WOODHAVEN/THIRLANE WATER

WOOD HAVEN PLAN & PROFILE 1

2
Sheet 2 of 7

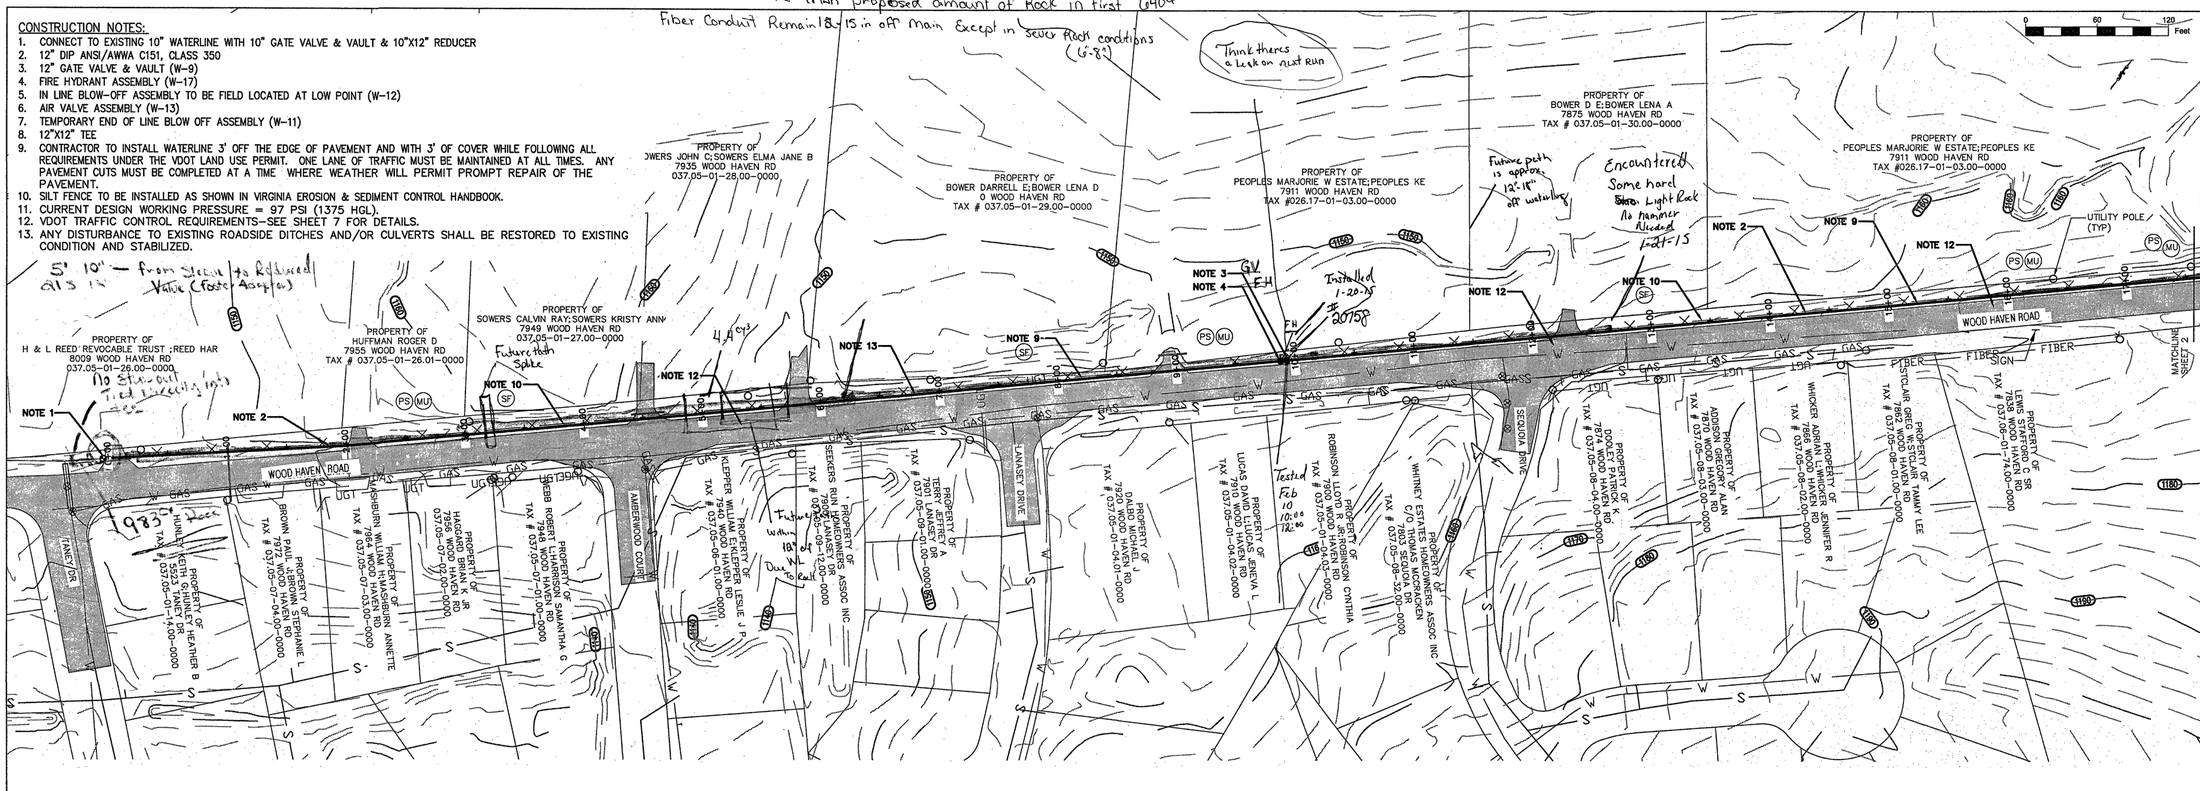
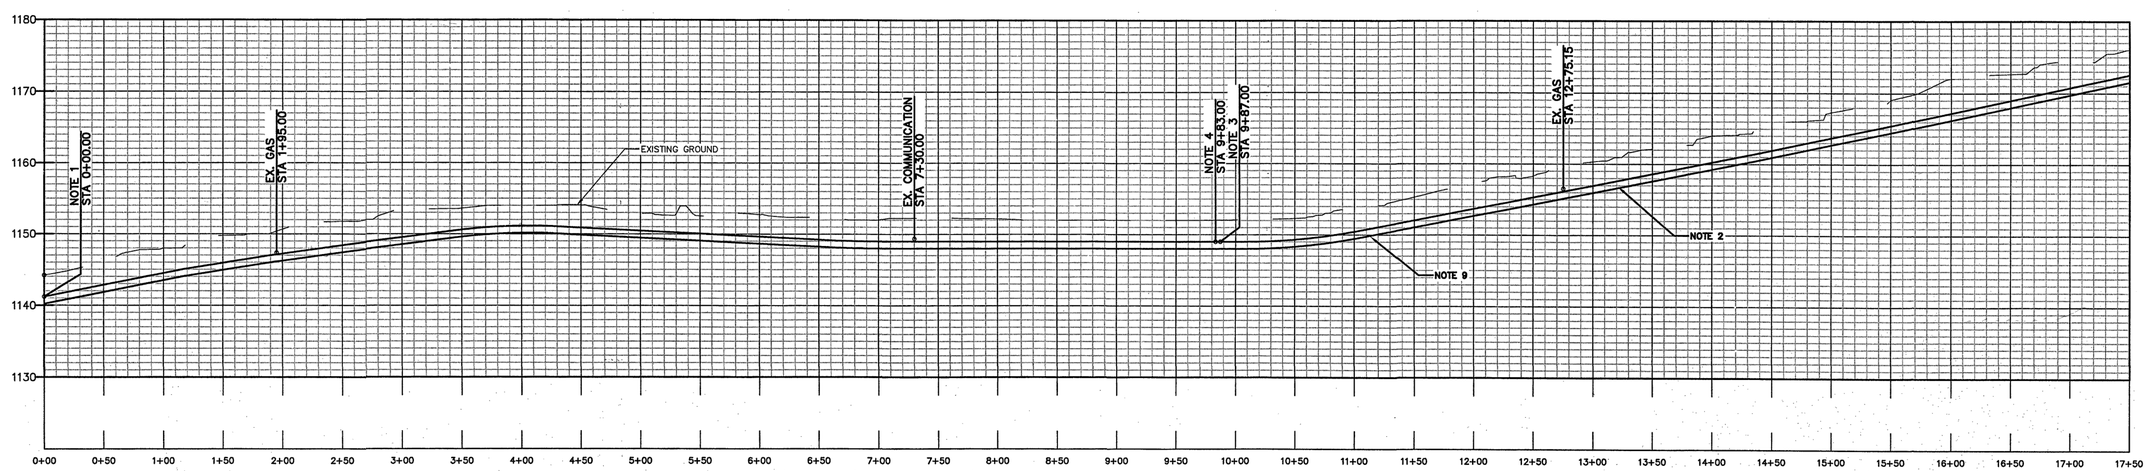
Have had more than proposed amount of Rock in first 1640'

Fiber Conduit Remain 18-15 in off main Except in Sewer Rock conditions (6'-8')

Think theres a Leak on last run
